Duke Power Company  
Oconee Nuclear Station

Attachment 1

15 EFPY Pressure/Temperature Limits

Low Temperature Overpressure Protection Technical Justification

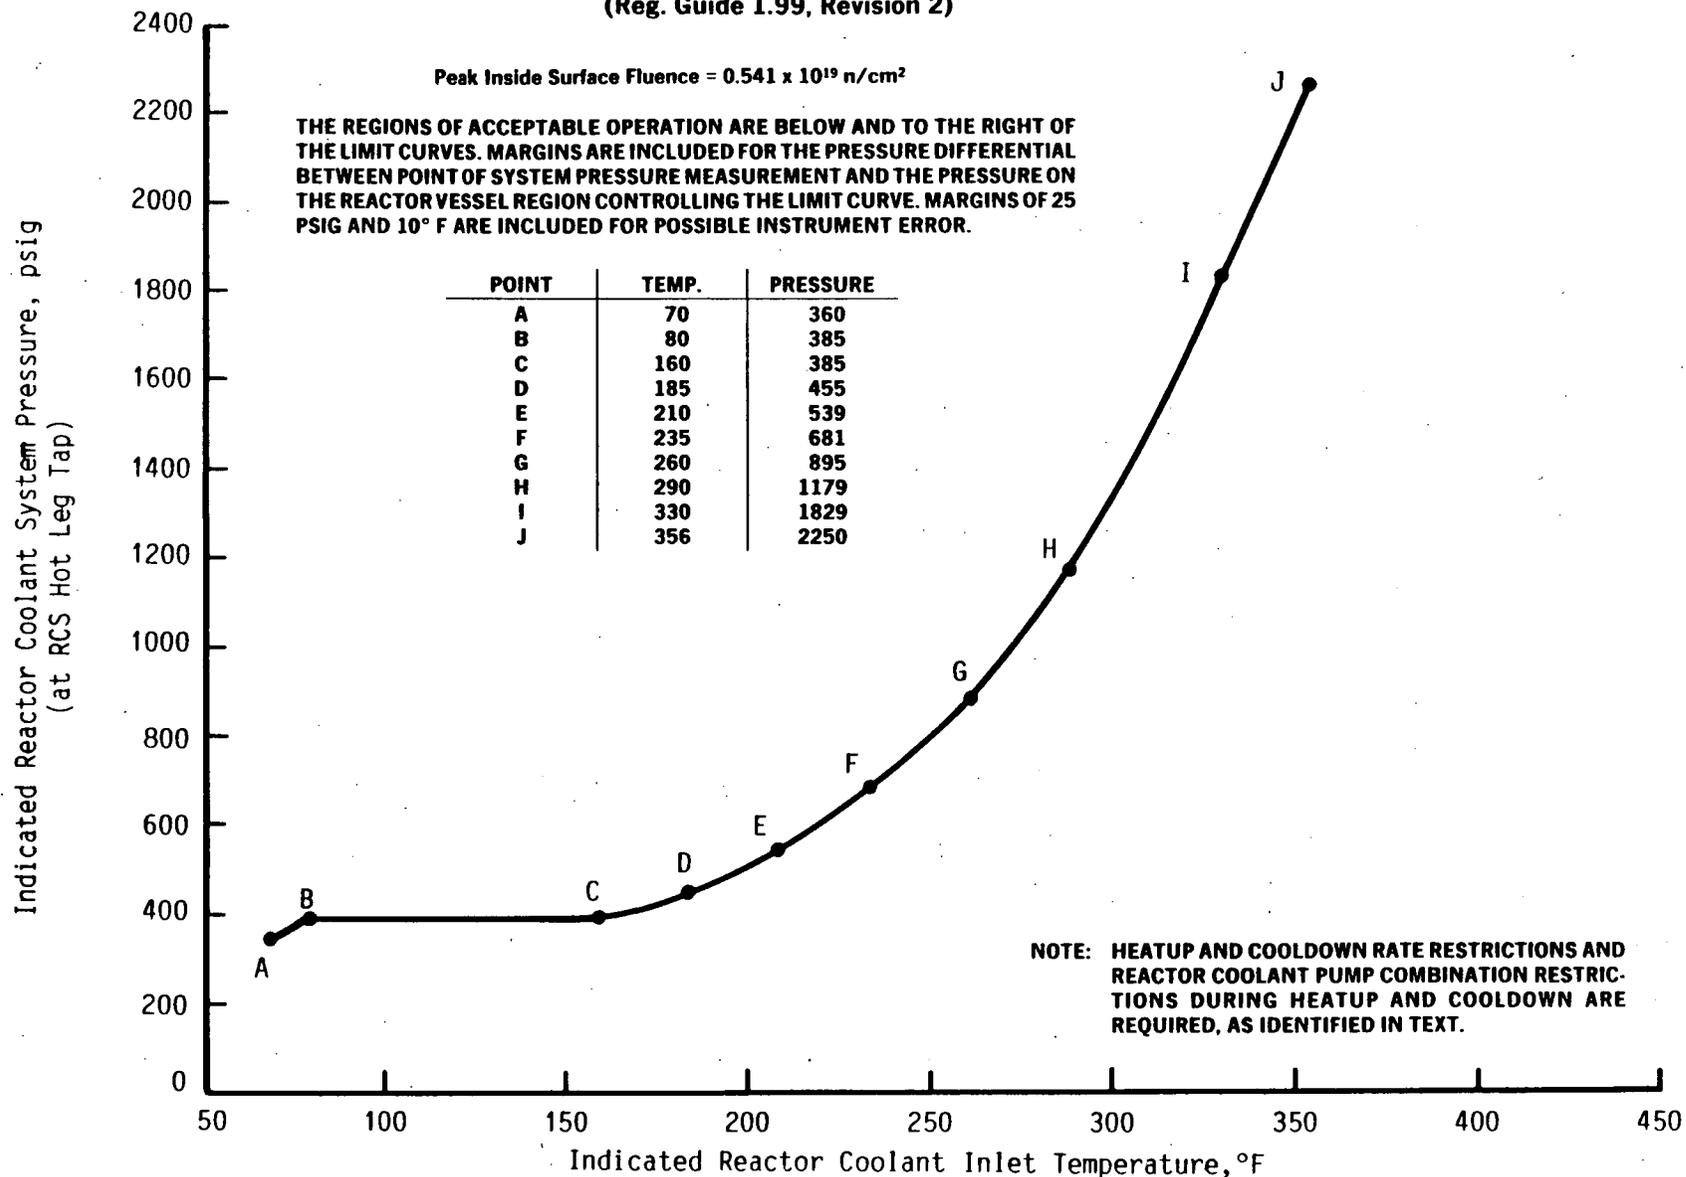
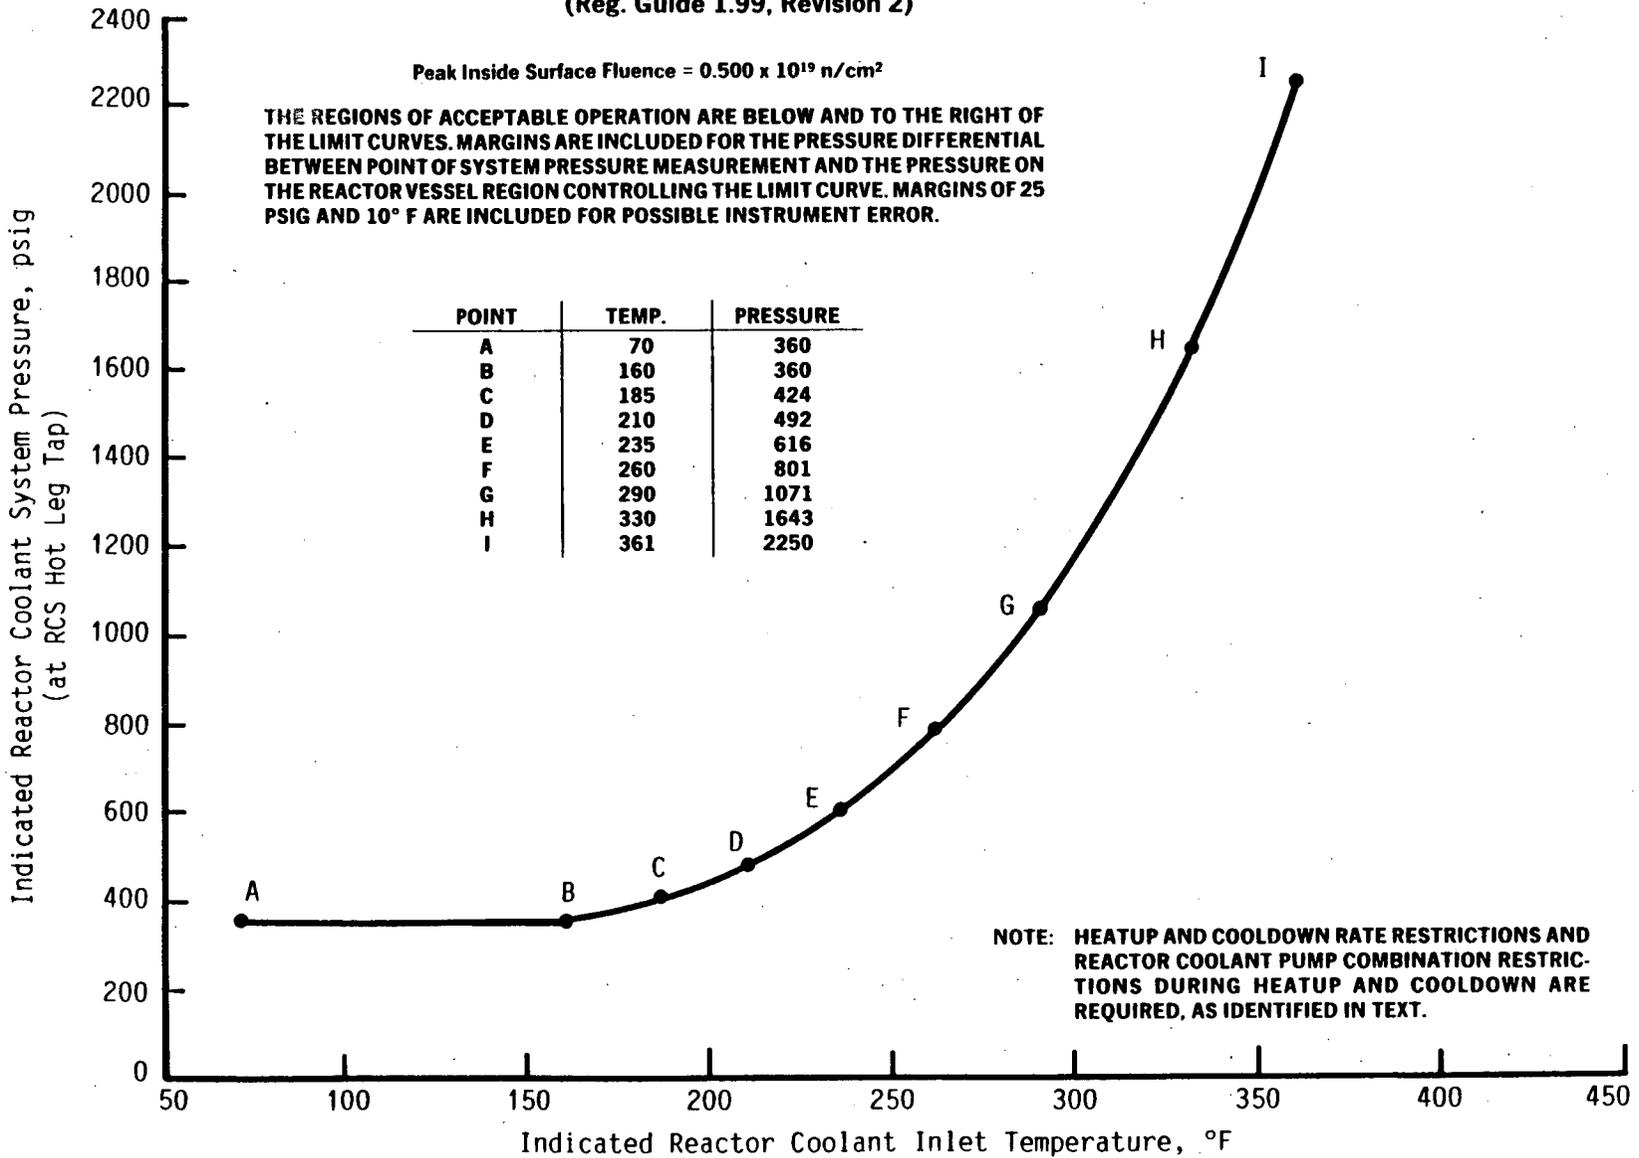
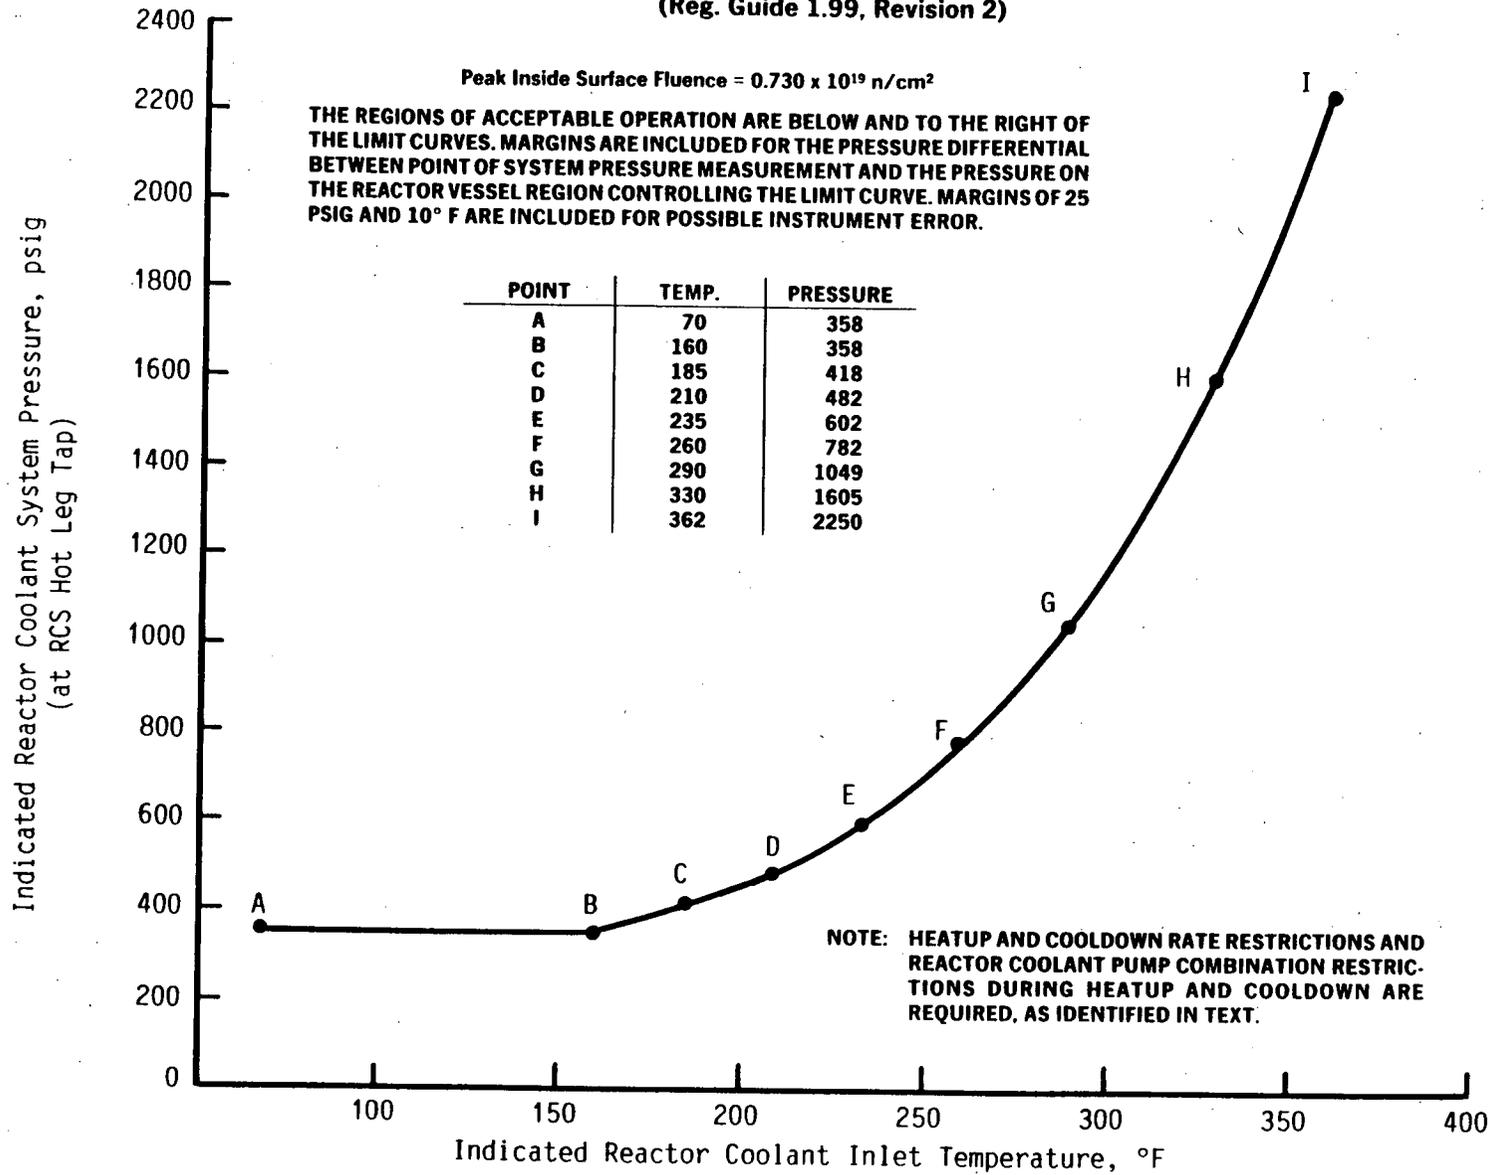
As required by GL 88-11, P/T limits revised in accordance with RG 1.97, Rev. 2 are provided in Figure 3.1.2 (Attachment 1). In addition, operational limits for plant heatup (including additional reactor coolant pump constraints) and cooldown are provided in Tables 3.1-1 and 3.1-2 respectively. The methods and criteria employed to establish operating P/T limits are described in NRC approved topical report BAW-10046A, June 1986. Thus, the revised P/T limits and heatup and cooldown constraints provided in Attachment 1 prevent nonductile failure during any normal operating condition, including anticipated operational occurrences and system hydrostatic tests.
